**From:** Joyce Hagen Mundy  
**Sent:** Wednesday, November 30, 2016 1:38 PM  
**To:** Meghan Boom  
**Subject:** FW: Homestead development concerns  
**Attachments:** 20161129153643070.pdf; D21E2B53-F34A-4BD4-9405-F1DEE059D9E2.pdf

**From:** Cory Childress [<mailto:cory@evan-talanhomes.com>]  
**Sent:** Tuesday, November 29, 2016 5:16 PM  
**To:** [info@tweakkc.com](mailto:info@tweakkc.com)  
**Cc:** Melissa Prenger; Wes Jordan; Keith Bredehoeft; Doug Sloter  
**Subject:** Homestead development concerns

**HOMESTEAD COURT  
 65TH TERR AND MISSION ROAD  
 PRAIRIE VILLAGE, KS  
 GRADING PLAN**

**Re: Homestead Country Club – Stormwater Management Study**

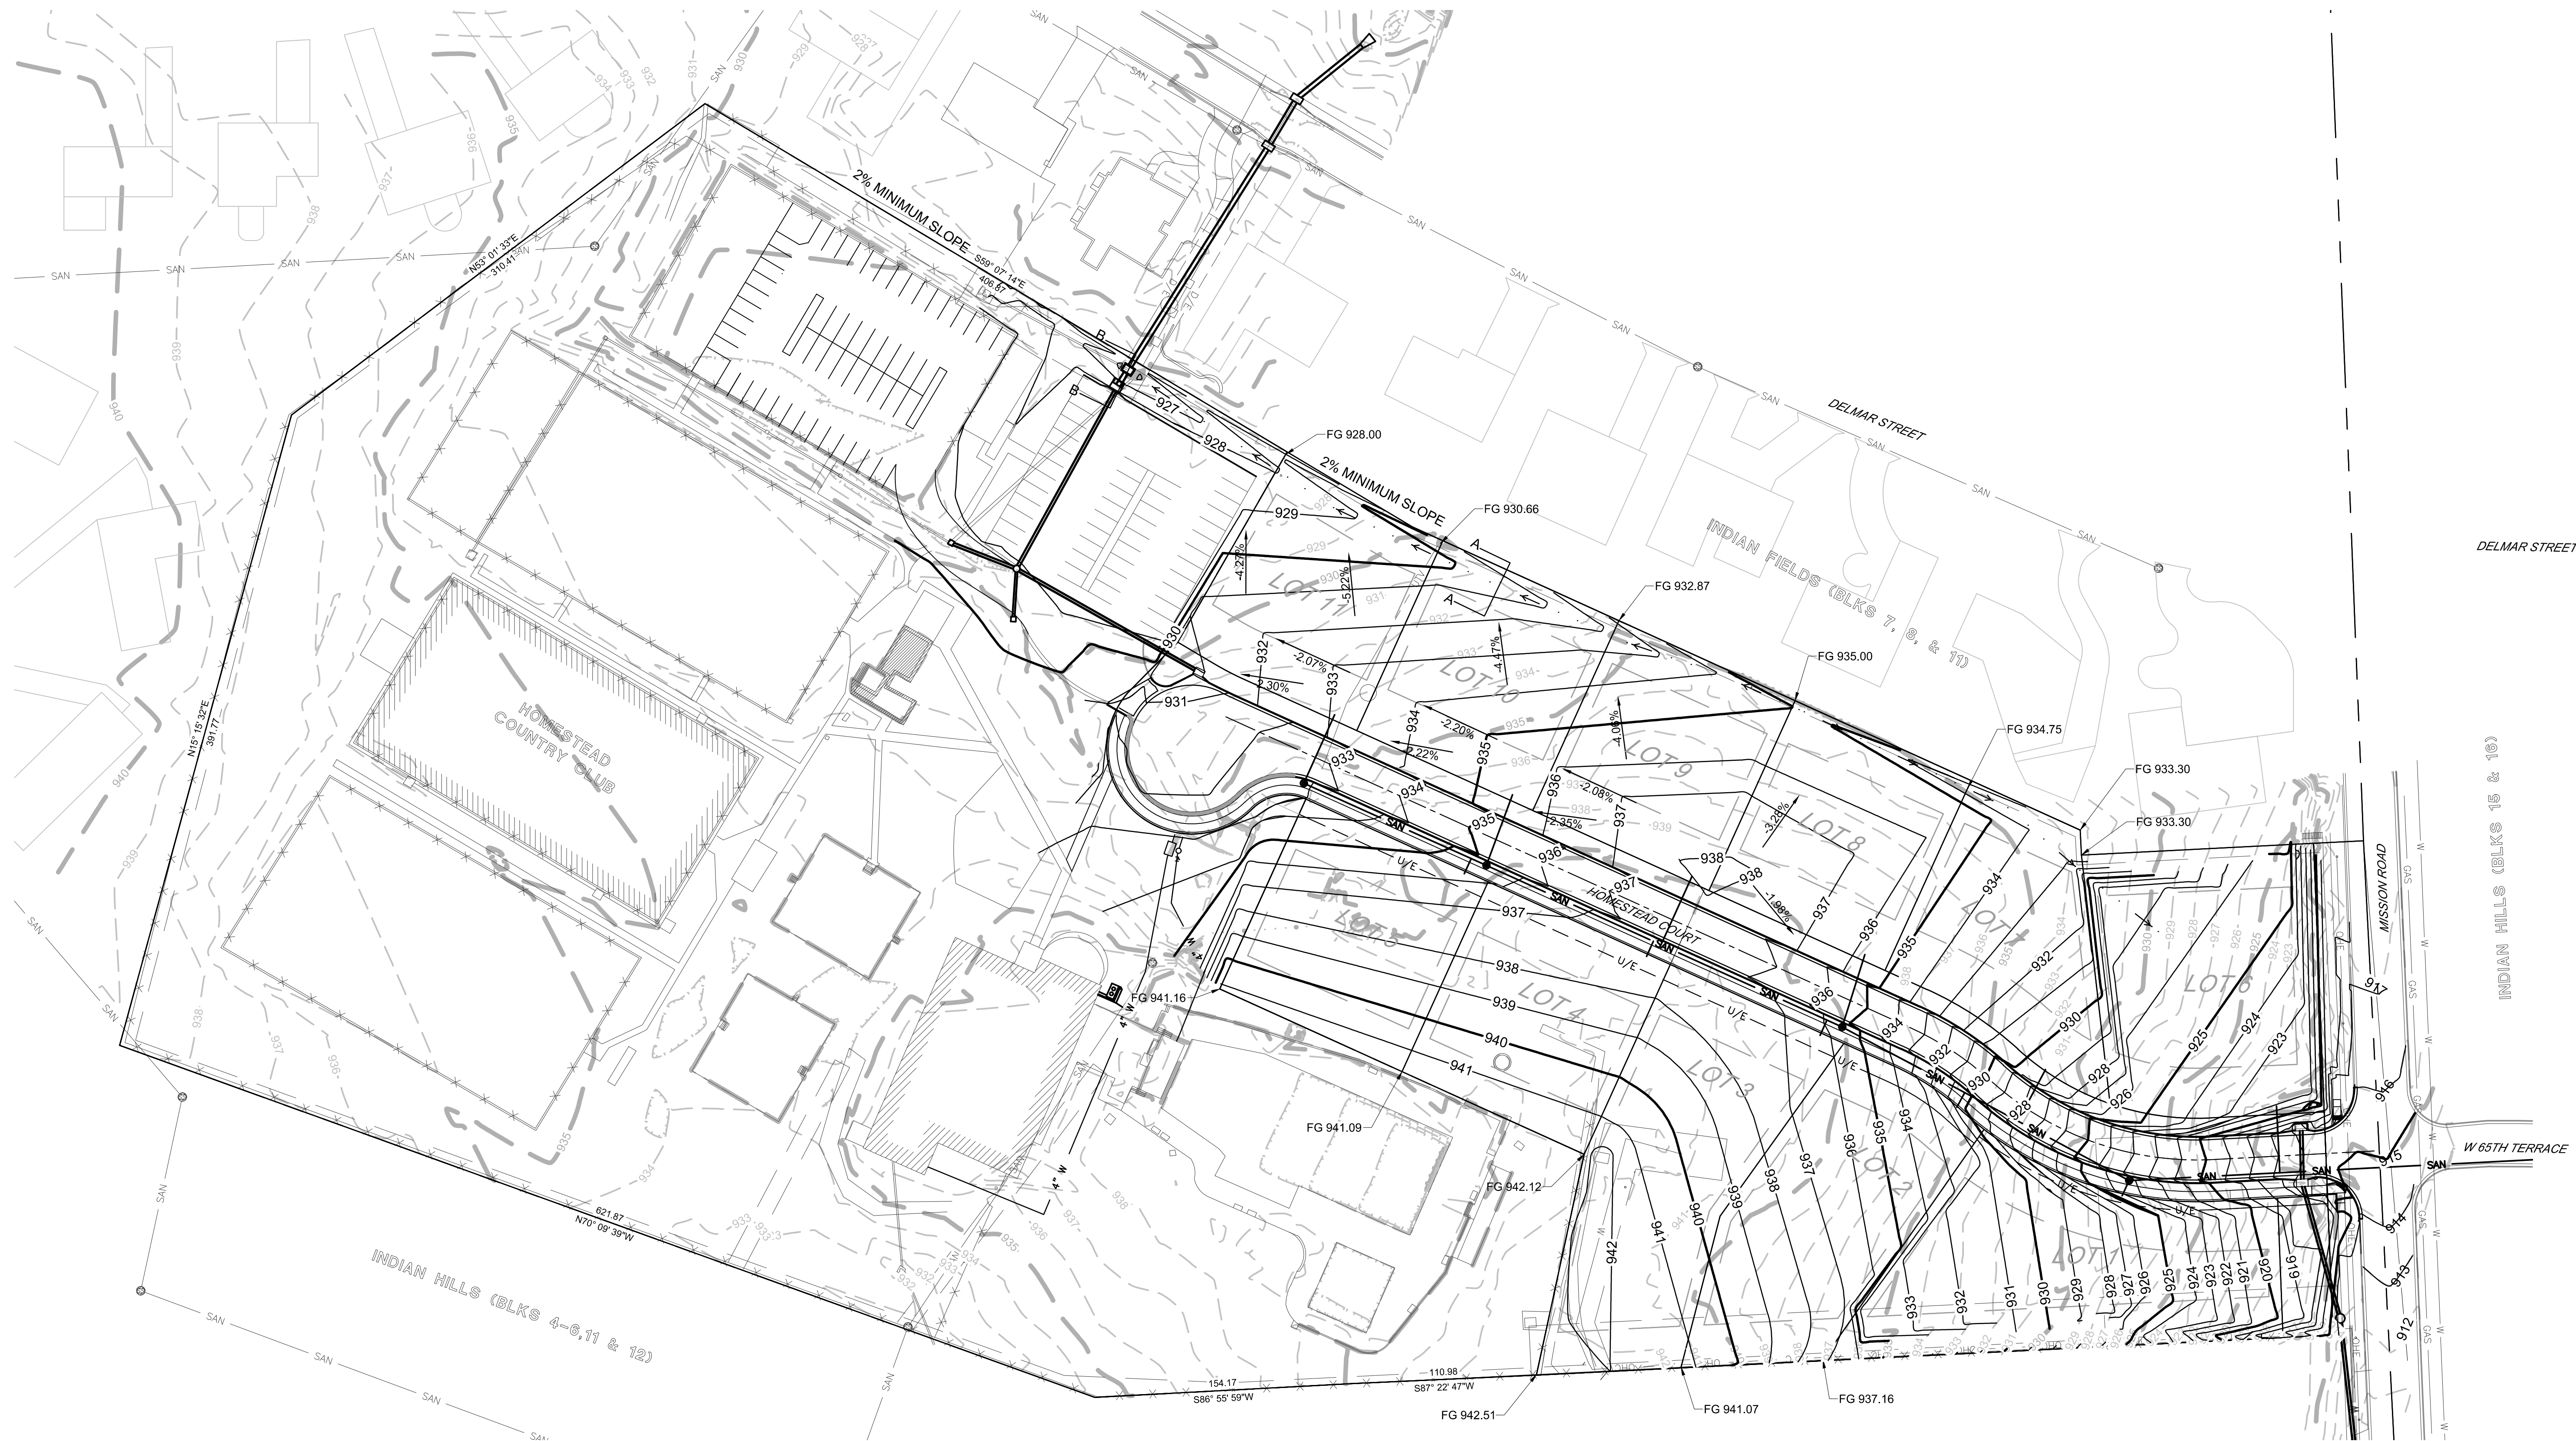
1. Address the grading plan to attempt to reduce the elevation on lots 9,10 and 11.
2. Address the need for a berm at the rear of where lots 6 and 7 meet to prevent water from flowing over the north property line.
3. Address the need to divert water flow from lots 1,2 and 3 flowing directly east and channel some of that water towards Homestead Ct.
4. Address the concern of obstruction of water flow in the berm/swale on the rear of lots 9,10,11 by future homeowners to ensure that they don't change the berm/swale in any way that could negatively affect it's performance.

1. BHC Rhodes has provided us with an alternative grading plan (see attached) that lowers the grade on lots 9,10 and 11 by approximately 12'. This is the most they could reasonably lower the grade and still direct water flow adequately. This also removes the berm and creates a swale which should work better and also be more aesthetically pleasing for all. This plan removes approximately 2,300 square yards of soil.
2. This will be addressed with a slight berm with the city's approval of the final design.
3. This will be addressed with a slight berm with the city's approval of the final design.
4. This will be addressed either through language incorporated into the deed restrictions or through creating a drainage easement which would allow the city to have more direct control of the drainage

**GRADING PLAN**

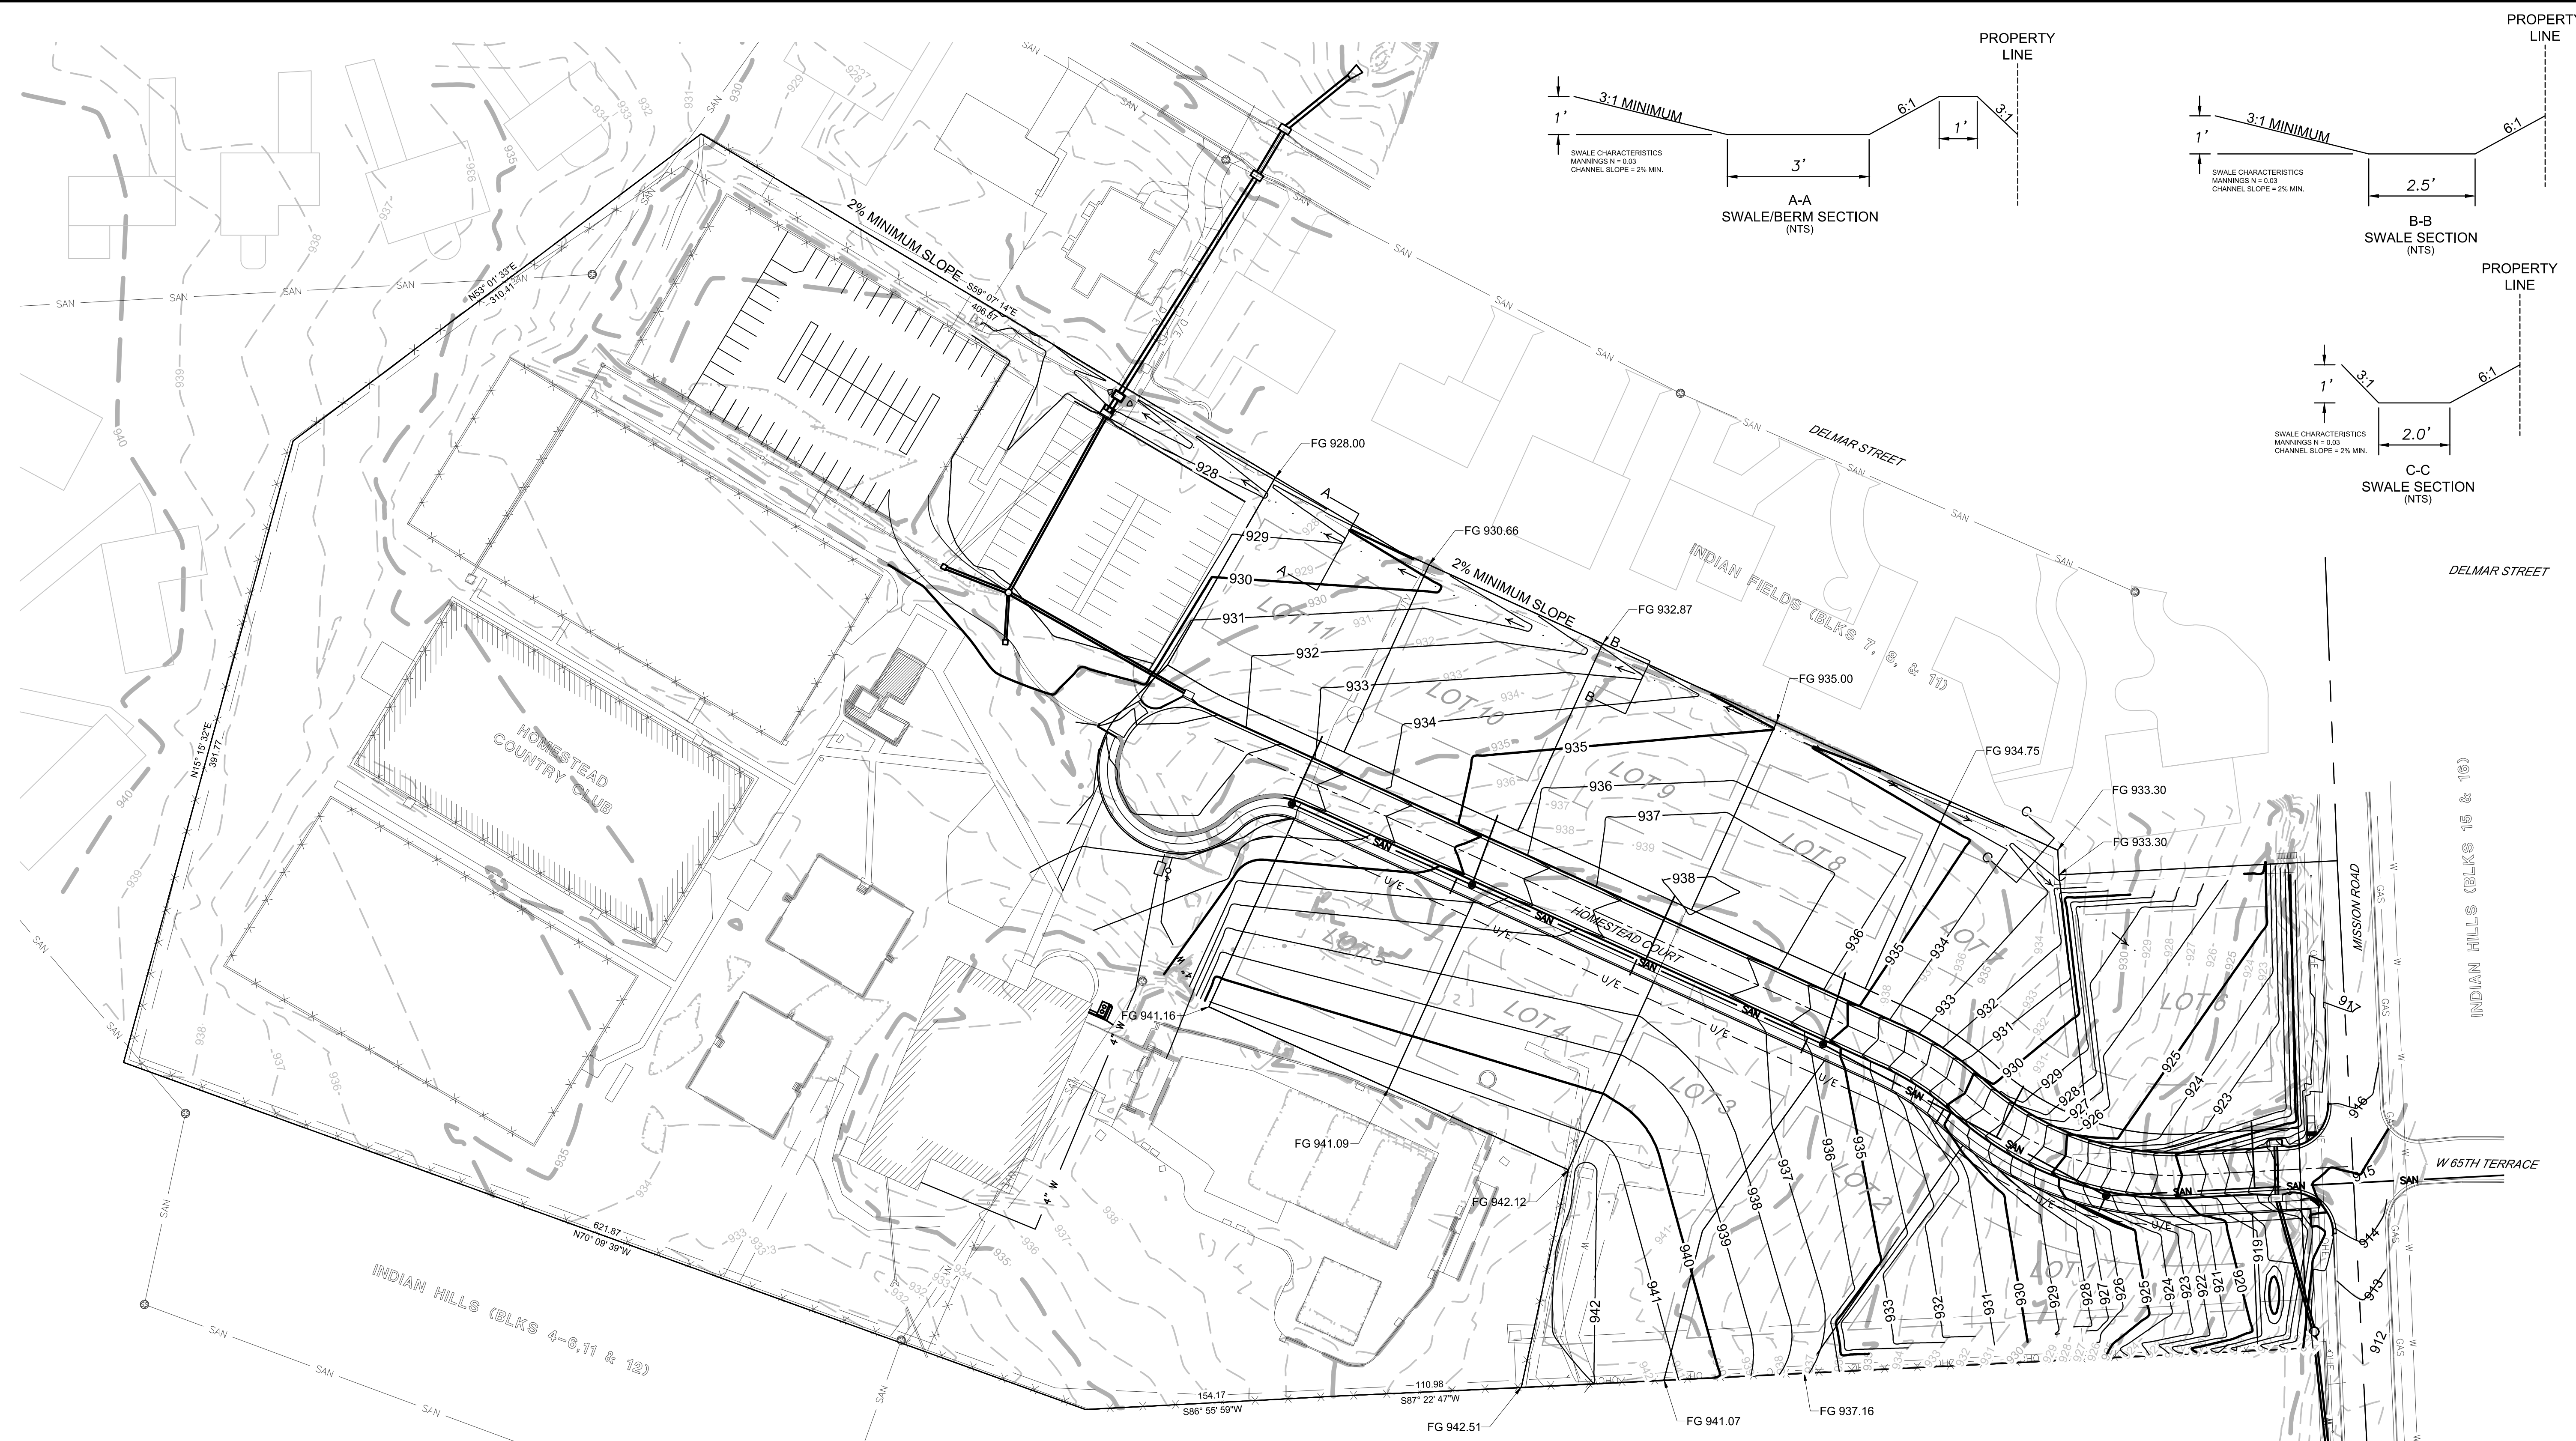
I am forwarding the plan with the cross sections to show the new ditch section on lots 7-10. The berm will be developed on lot 11 illustrated by section AA.

Cory should be able to provide cross sections of the modified channel at the north property line today as well. We asked that they lower the channel from the property line to make it better than is today. The cross sections will help in understanding this. We will still have a berm close to the drainage inlet but the channel will be regarded and lowered in this location. This grading change along with a drainage easement and/or deed restrictions will allow for the city to ensure proper function of this channel into the future.

1. BHC Rhodes has provided us with an alternative grading plan (see attached) that lowers the grade on lots 9,10 and 11 by approximately 12'. This is the most they could reasonably lower the grade and still direct water flow adequately. This also removes the berm and creates a swale which should work better and also be more aesthetically pleasing for all. This plan removes approximately 2,300 square yards of soil.

2. This will be addressed with a slight berm with the city's approval of the final design.
3. This will be addressed with a slight berm with the city's approval of the final design.

**EXHIBIT 3: SWALE DIMENSIONS AND SWALE CAPACITY**

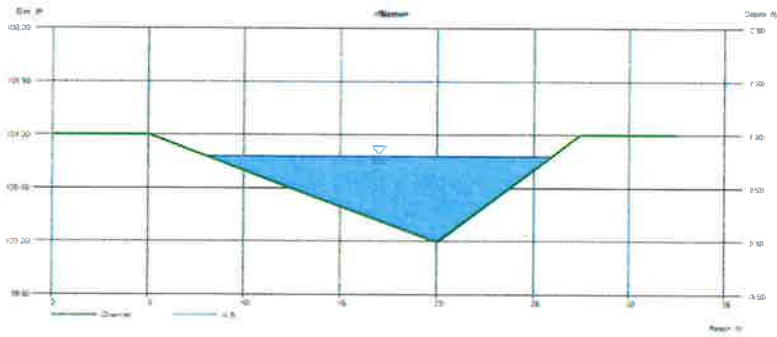
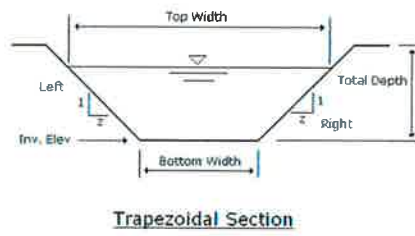
Analysis determined that the swale can sufficiently handle the 24-hour, 500-year design storm. This storm is beyond the city requirement but used as a reference to its overall capacity. Refer to **Exhibit 3** for the cross-section of the swale along with the capacity of the swale at different depths.
